RFI Response – Aviation Safety Report, Graham Liddy

Ref 04.PA0045

REPORT REGARDING AVIATION SAFETY AT PROPOSED WASTE TO ENERGY PLANT

RINGASKIDDY, Co CORK

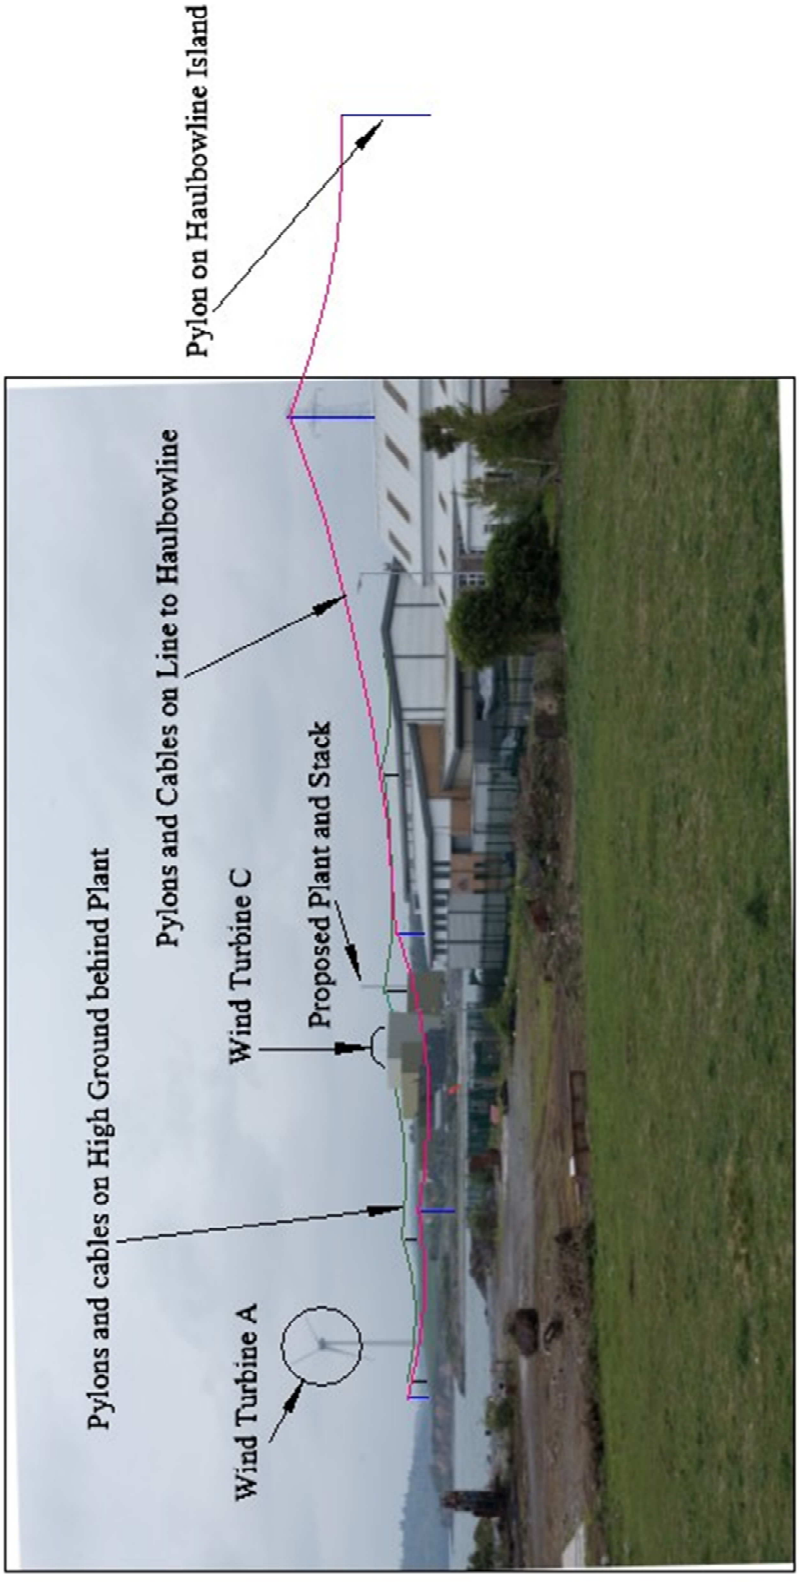
6.4.16.12. The photo below, looking generally south from the area of the Football Field, gives an indication of the present obstacles that are encountered when taking-off from the Football Field towards the general area of the proposed plant. Wind Turbine A can be seen, as can the high pylon on Rocky Island. The photo also shows the clear area of water in the left, towards the south-east, (which lies between the Ringaskiddy area and Spike Island) which would be the natural, obstacle-free flight path that a pilot would use when operating from the Football Field:

6.4.16.13. Below is a similar photo, but with a narrower view, also taken from the Football Field, which show the obstacles in the area of the proposed plant somewhat more clearly.

6.4.16.14. This is the same phots as that above, but with the proposed plant inserted to scale.

6.4.16.15. This is the same picture, but with the current obstacles enhanced for visibility. The location of all these obstacles can be seen in the image in Appendix O and the plan view diagram in Appendix P.

Appendix O Cork Harbour with 500 ft Radius Area and 500 meter Circles

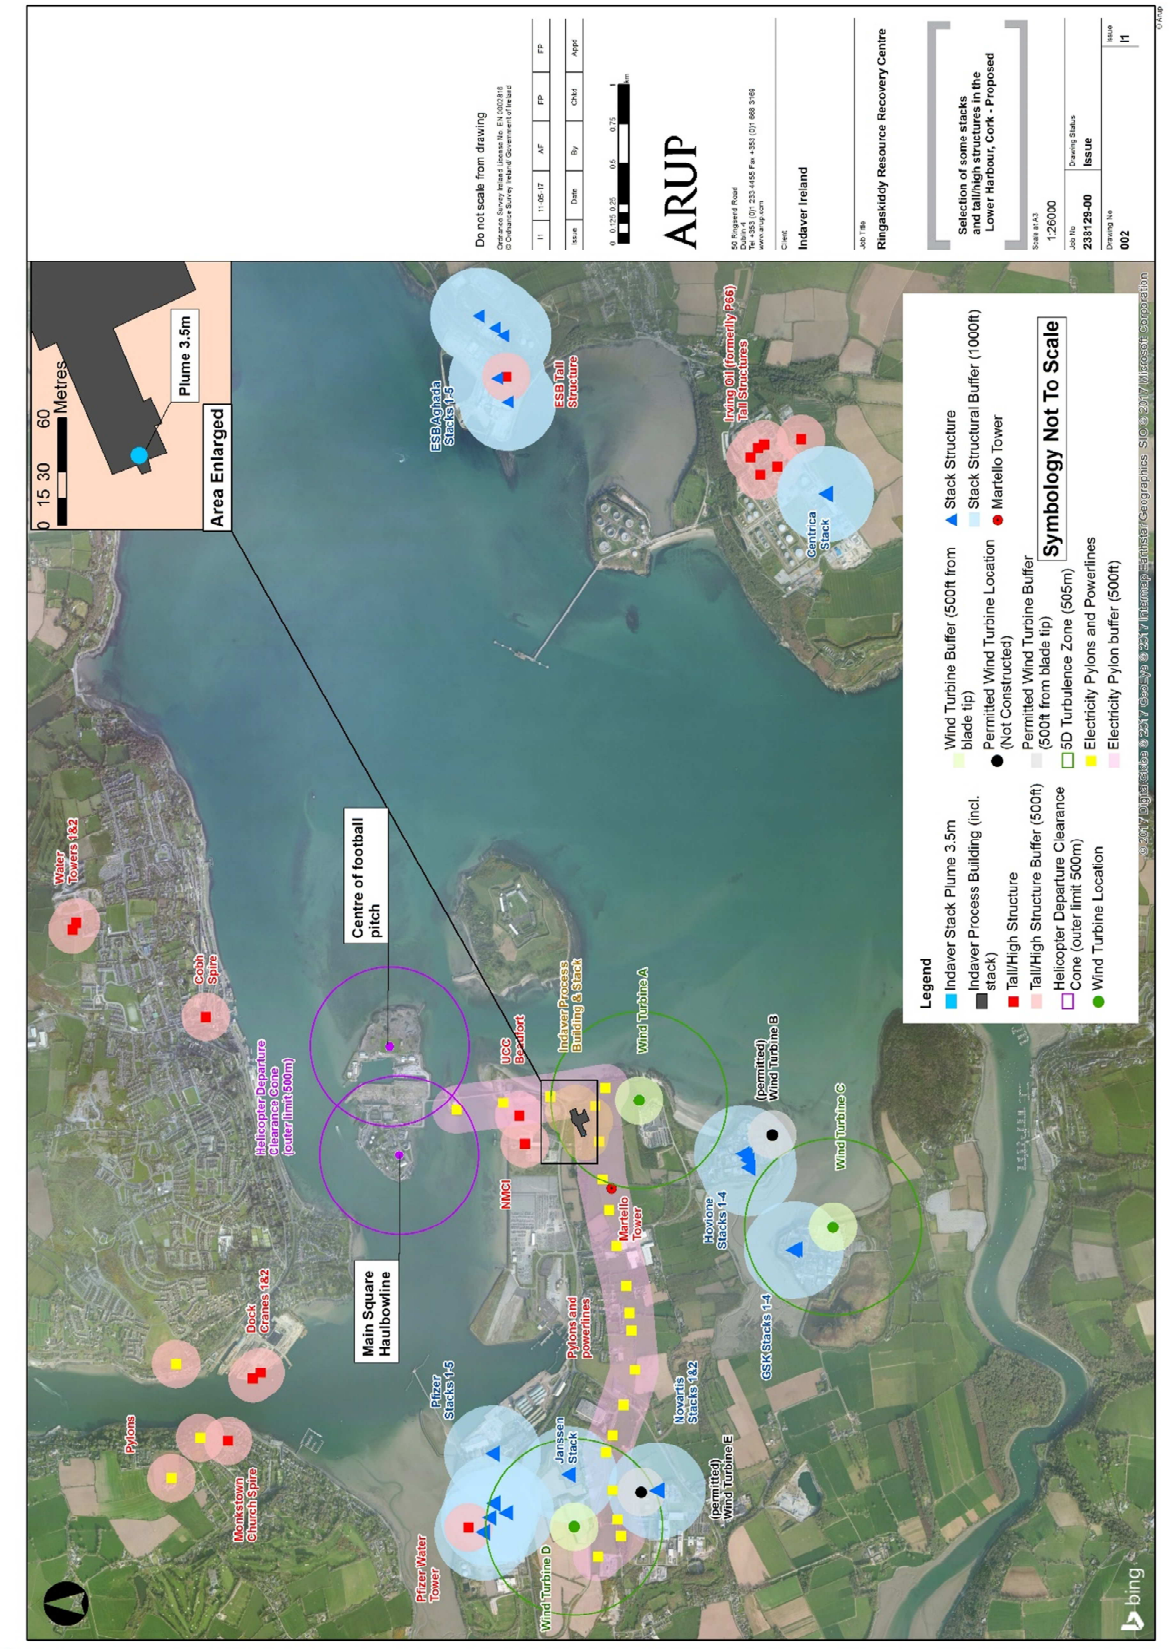
This Appendix shows all the significant obstacles in the Cork Harbour area, with an orange pink circle representing, to scale, the extent of a 500 ft obstacle clearance circle drawn around the top of the stack of the proposed plant. The Appendix also two green circles centres on the Main Square and the Football Field respectively. These circles have a radius of 500 meters and represent the limit of the 6° cone used by the UK Armed Services Joint Standards, whichis used in helicopter operations as described in Para 6.4.16.3, et al, above. These circles are significant in that, within the circles, the 6° cone must be clear, and when the helicopter has reached the 500-meter circle, it is capable of turning in any direction to avoid obstacles outside the circle. The image shows that the pylon on Rocky Island is the only obstacle within these circles, and as show in Appendix P, it does not impinge into the 6° cone.

The 500-meter circle is also significant with regard to the circling recce, in that in the two cases noted in Para 6.4.4, (Quilty and Knockalough) the actual Air Crops recce circles were conducted within a 500-meter circle of the landing point, as opposed to the 800 – 1,000 meters claimed in the DOD submission.

The image shows the 3 existing wind turbines located in the sector south to west of the NS base and also 2 new turbines which has been granted permission.

As can be seen on this image, the area around Ringaskiddy, had a very high density of obstacles, several of which are much higher than the proposed stack. The area is clearly not suitable, in its current configuration, for low level helicopter operations. The proposed plant would not place any further restrictions on the operations of helicopters in this area.

Do not scale from drawing
ARUP
Indaver Ireland
Ringaskiddy Resource Recovery Centre
Selection of some stacks and tall/ high structures in the Lower Harbour, Cork - Proposed - Larger Scale

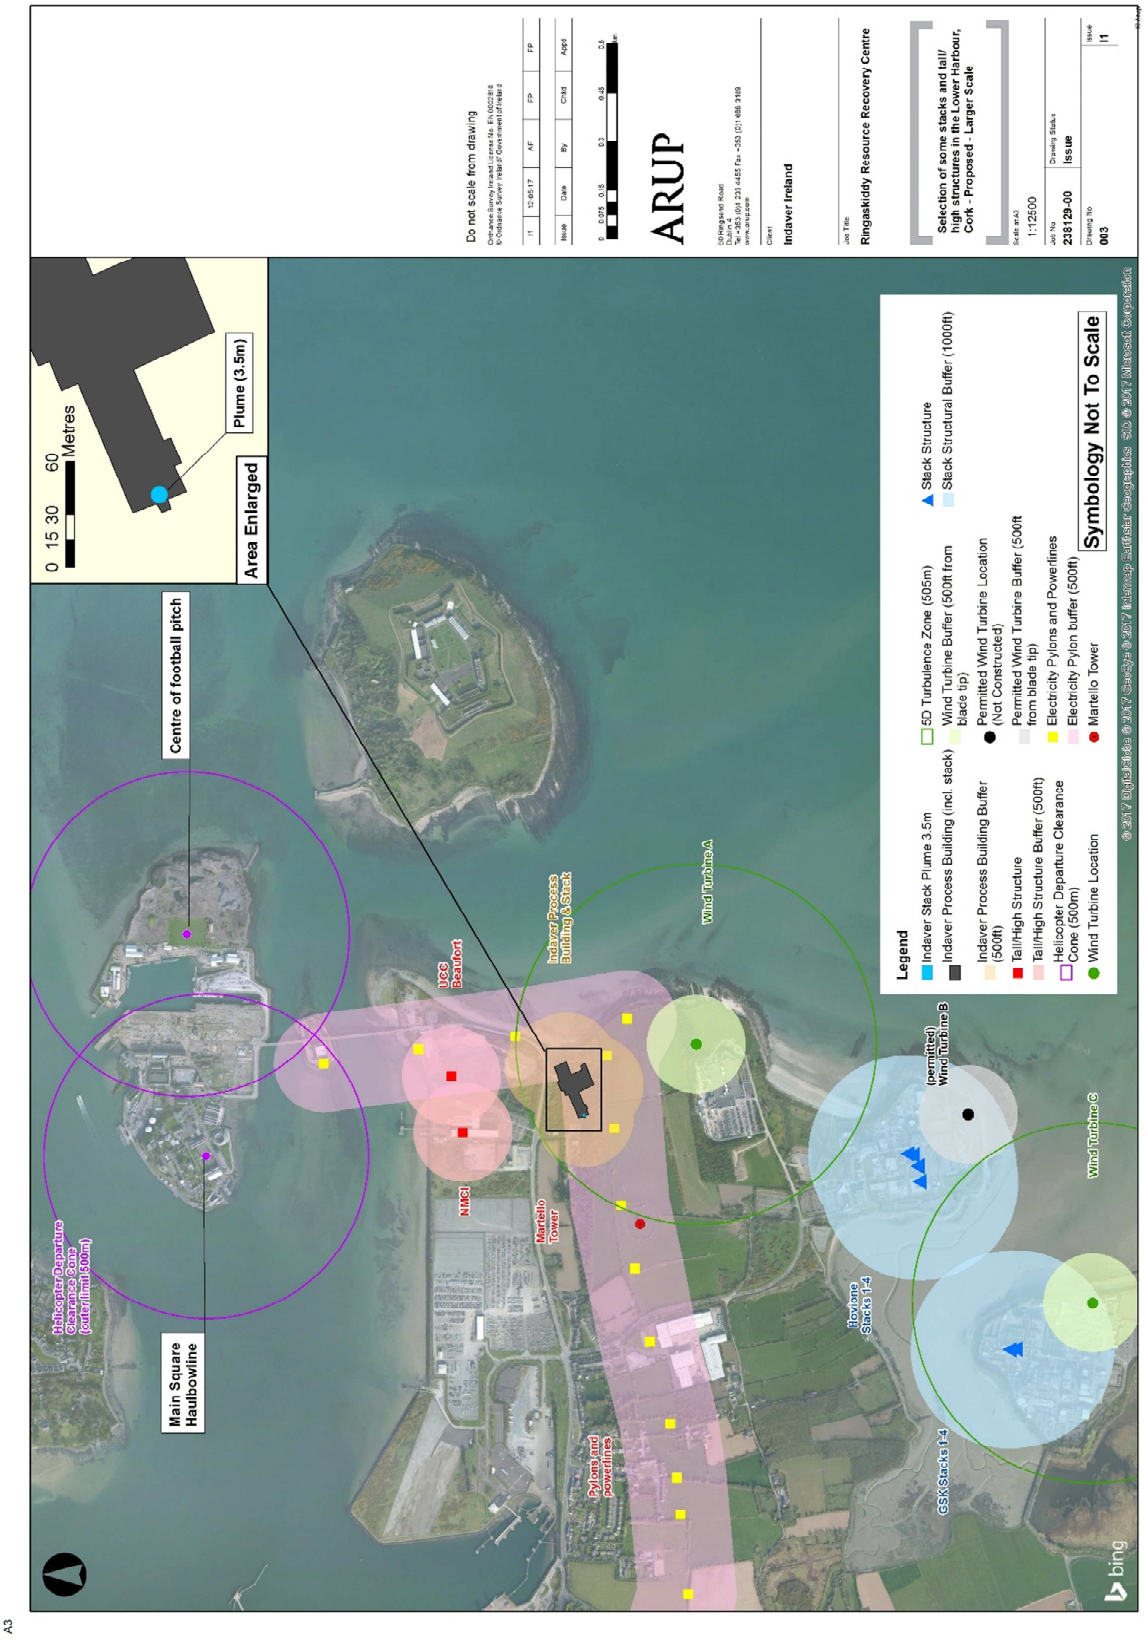
The next image shows the NS base area in close up, and clearly shows that a significant clearance exists between the 500 meter radius limits of the 6° clearance cone and the proposed plant, and between these radius limits and a 500 ft obstacle clearance area around the plant.

The inset in the top corner, is the proposed plant shown at an increased scale. The blue circle in this enlarged inset is the 3.5 meter radius circle showing the maximum possible extend of the possible dangerous area surrounding the top to the proposed stack, as discussed in Para 6.27.1. The corresponding small blue circle in the main diagram clearly shows the very limited extend of this danger area in relation to the NS base and other obstacles in the area.

Appendix P Helicopter 6° Take-Off Cone

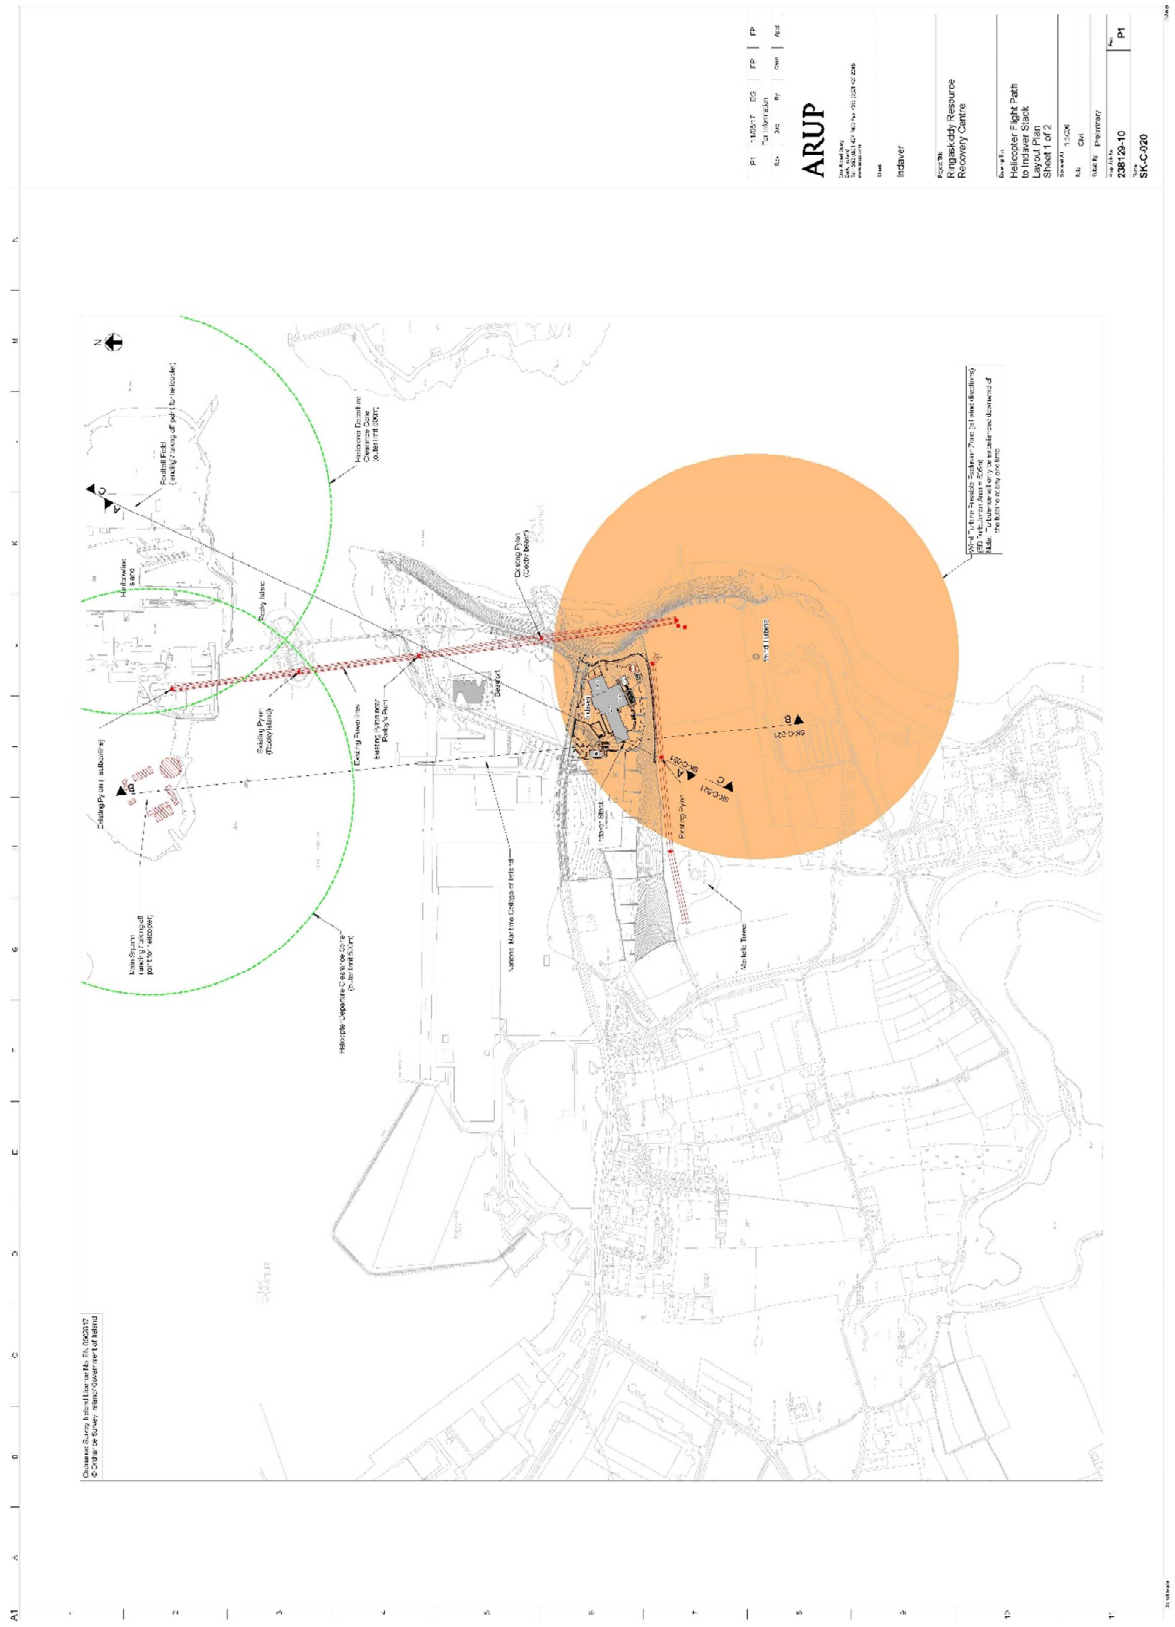
This diagram shows the flight paths from the Main Square to the proposed plant, and from the Football Field to the proposed plant. The red line is the high power line leading from the mainland, over Rocky Island to the NS base on Haulbowline, , which continues on a line east-west on the high ground directly south of the proposed plant. The orange circle is the 5D circle from the existing Wind Turbine A, which is the area in which severe turbulence from the wind turbine may be expected. The diagram shows that the wind turbine turbulence danger zone completely envelopes the proposed stack and plant.

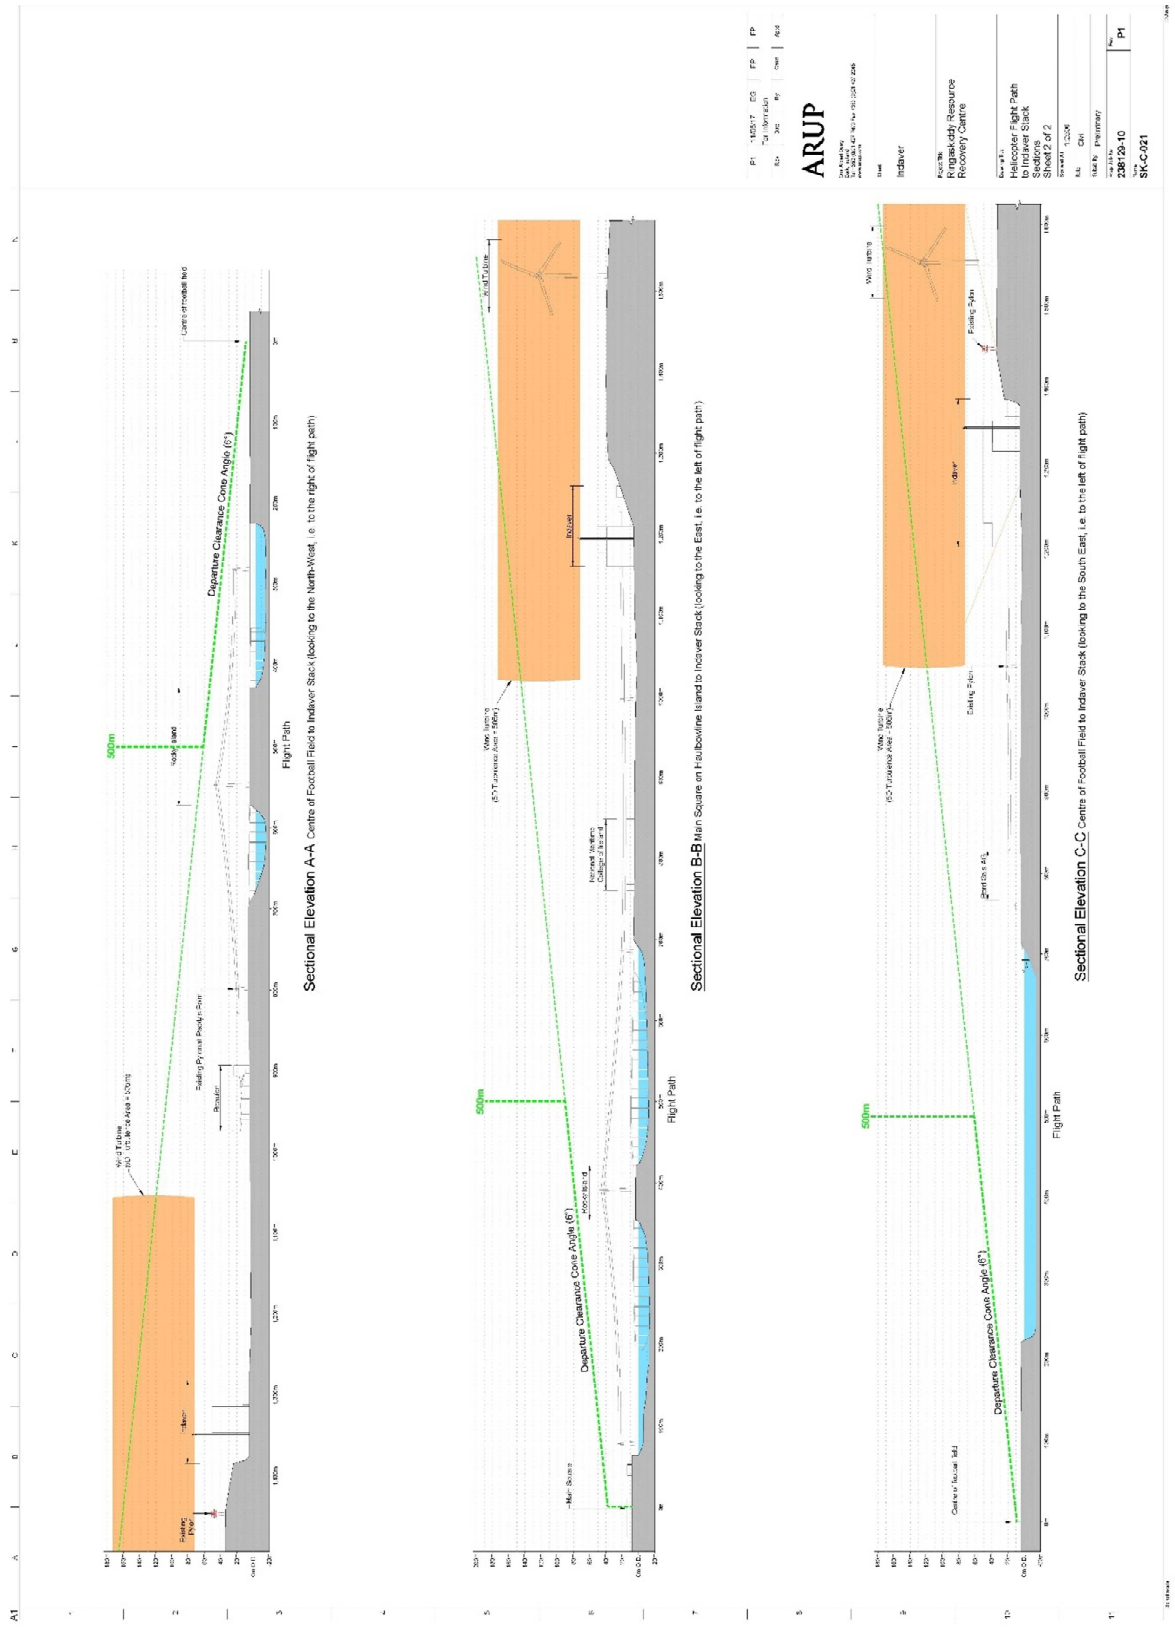
The next diagram shows the elevation views on the flight path lines from the NS base to the proposed plant. The 6° clearance cone used by the UK Joint Standards, and the 500 meter limit of this cone, is also shown in these elevations.

Section CC is the elevation from the flight path, from the Football Field to the proposed stack, looking to the south-east, i.e. to the left of the flight path.

Section BB is the elevation from the flight path, from the Main Square to the proposed stack, looking to the east, i.e. to the left of the flight path.

The elevations clearly show that:

There is no obstacle which penetrates the clearance cone. The high pylon on Rocky Island comes closest to penetrating the cone.

The 5D turbulence danger zone from Wind Turbine A completely envelopes the proposed stack and plant, and is, by far, the dominant hazard in the area.

Appendix Q Turbulent area due to wind turbine

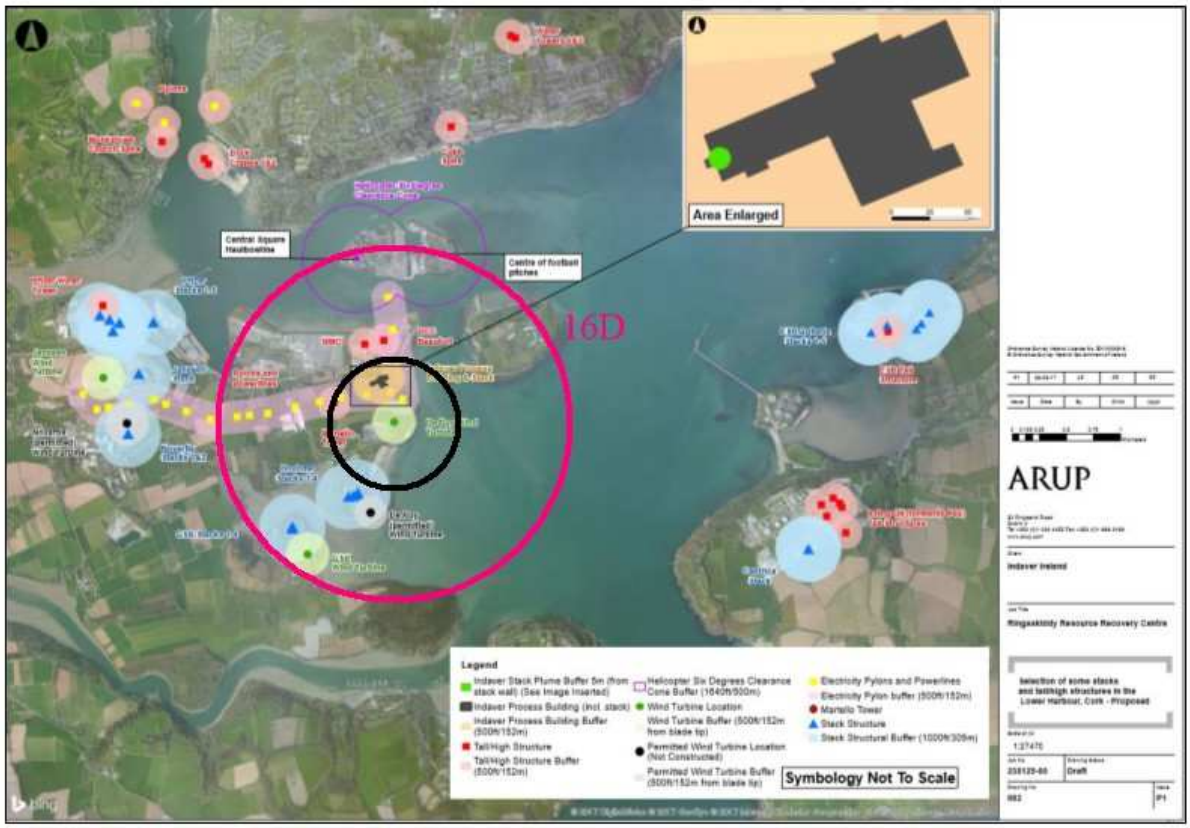
This image shows the horizontal limits of the turbulence zones from Wind Turbine A. The black circle indicates the 5D limit where dangerous turbulence can be expected, while the red zone indicated the 16D limit where turbulence can be expected. The 16D limit indicates and area where the turbulence would not be dangerous, but could be problematical when conducting underslung load operations.
